Informal Document No. GRE-60-21
(60th GRE, 1-3 October 2008
agenda item 10(a))

Information for Proposed amendments to Regulation No. 53 for headlamp corresponding to inclination

Explanation about “the horizontal inclination”, “the bank angle” and the angle “ δ ”.

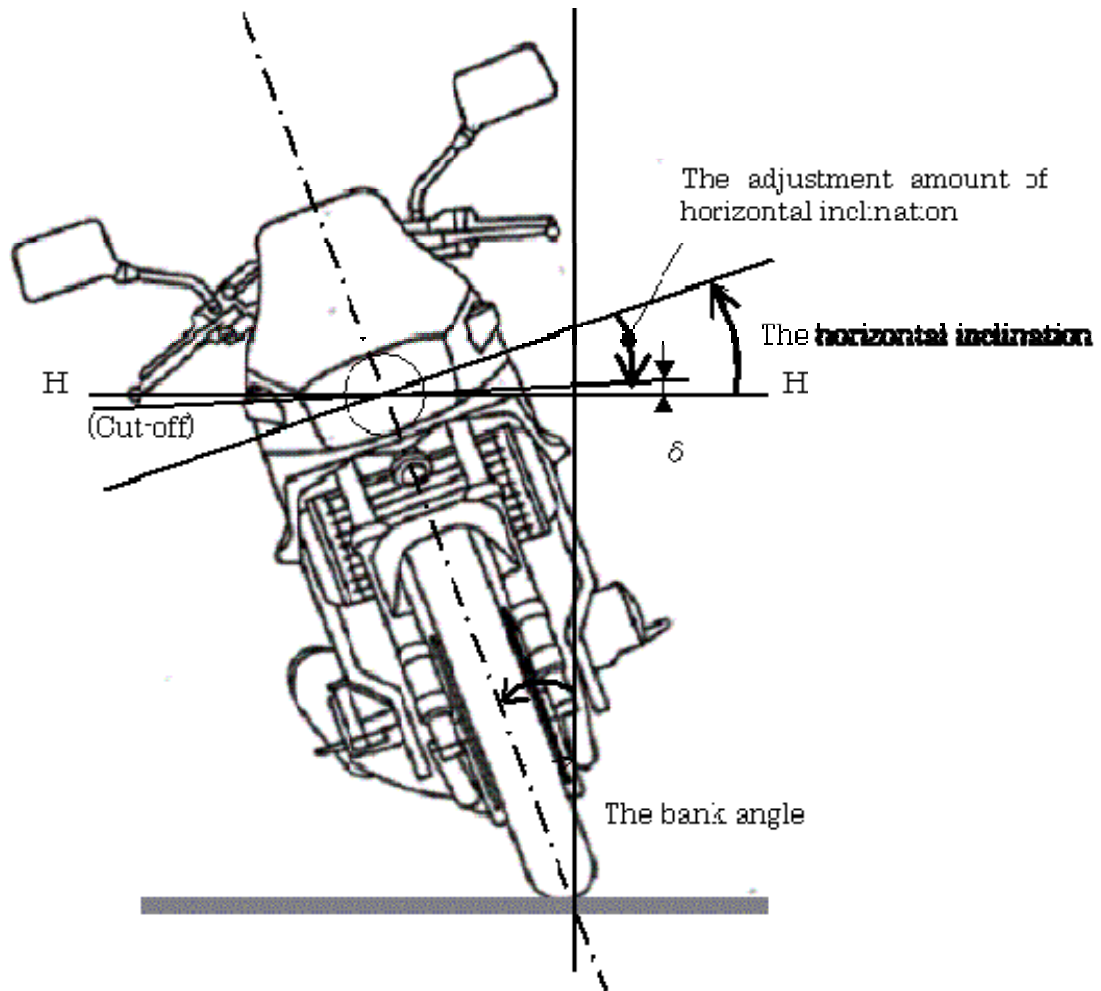
“**2.21** “The horizontal inclination” means the angle created between the beam pattern when the motorcycle is set as specified in paragraph 5.4., and the beam pattern when the motorcycle is banked. (see drawing in annex 6)

2.23 “the bank angle” means: the angle made with the vertical by the vertical longitudinal median plane of the motorcycle, when the motorcycle is rotated about its longitudinal axis. (see drawing in annex 6)

- Incline the vehicle with the following conditions and measure the angle δ created by headlamp cut-off line (in case of asymmetrical beam headlamp, it's horizontal part of cut-off is used) and HH line. (see drawing in annex 6)**

- Test procedures for confirming that the adjustment amount of horizontal inclination will not exceed the vehicle’s bank angle have been specified. δ is the angle created by cut-off line and HH line. When this angle is zero or above, no glare will be given to oncoming vehicles. In addition, the statement to the effect that signals for activating the AFS may be input from the outside during testing if necessary, which was developed based on Paragraph 3.1.1. of Annex 9 to ECE R No. 123, has been added.
- The specifications of “HIAS failure” tell-tale are exactly the same as that for driving beam headlamp, and the same indicator may be used for both headlamps.

Figure 1. Description of the Function of the Inclination Angle adjustment-Type AFS

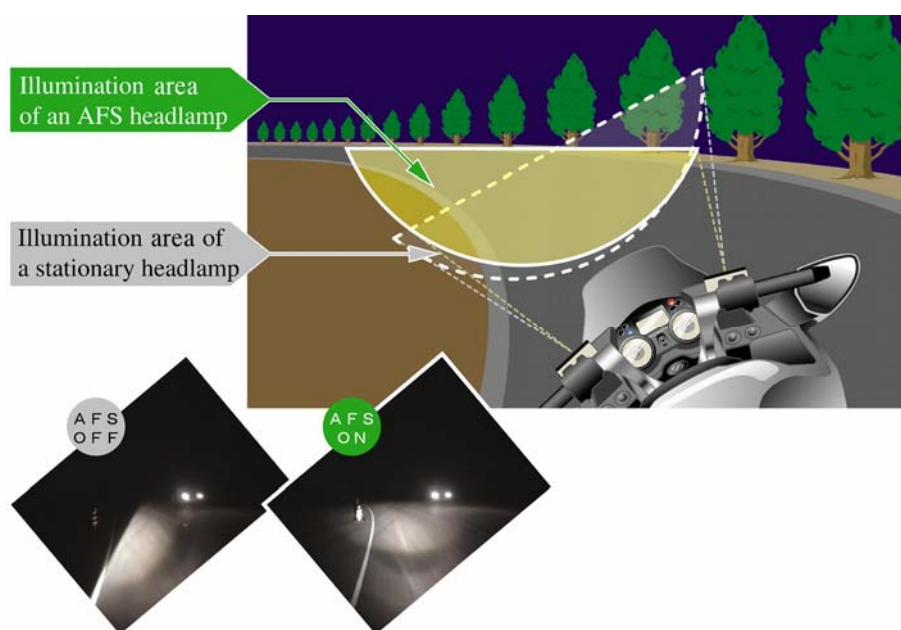
In the case of a motorcycle, due to its driving characteristics, the headlamp inclines with the vehicle when the vehicle is running on a curved road, narrowing the illumination area of the headlamp in the traveling direction. Therefore, by adjusting the variation of the headlamp's light distribution from that when the vehicle is upright, *i. e.*, in the standard condition, to keep the illumination area wide enough, the visibility is expected to improve.
